Staff Report & Recommendation

Historic Preservation Board

SUBJECT: HPB23-0575, **100 Block of Lincoln Road Right-of-Way and 1 Lincoln Road.**

FILE NO: HPB23-0575

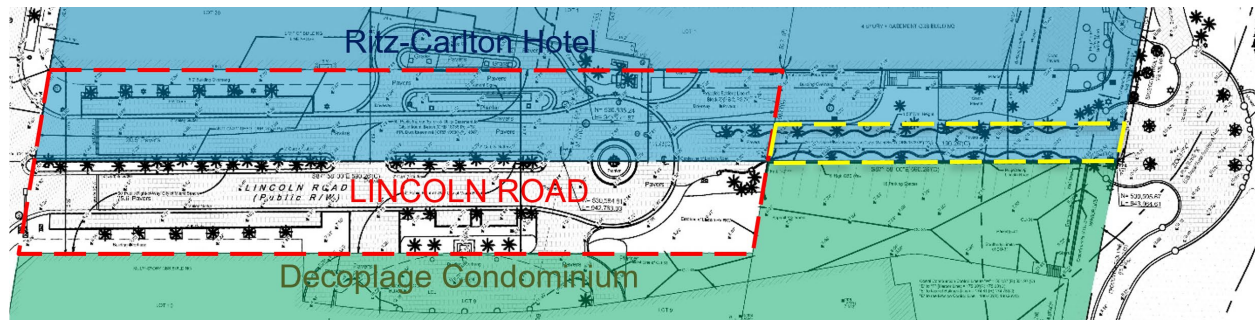
Staff would preface this analysis by noting the unique ownership conditions of the portion of Lincoln Road east of Collins Avenue. As can be seen in the diagram below, the northern half of what is recognized as Lincoln Road (red) is actually part of the Ritz-Carlton Hotel property (blue). Additionally, the northeastern corner of the Decoplage Condominium (green) property extends north to meet the Ritz-Carton property. In order to provide access to the Beachwalk, the City has a 20'-0" wide pedestrian access agreement (yellow) within the southwestern corner of the property.

The subject application is limited to improvements to Lincoln Road (including the portion owned by the Ritz-Carlton and the pedestrian easement area (the areas outlined in red and yellow)). Improvements include the reconfiguration of the roadway and sidewalks, the introduction of decorative paving and enhanced landscaping. Additionally, the applicant is proposing to modify the Ritz-Carlton Hotel drop off area including the widening of the pedestrian walkway along this portion of the building and the introduction of a new driveway and loading area configuration. Staff would note that as part of a separate application (HPB23-0574), the application is also proposing the introduction of a new porte-cochere to provide protection for the proposed drop off area.
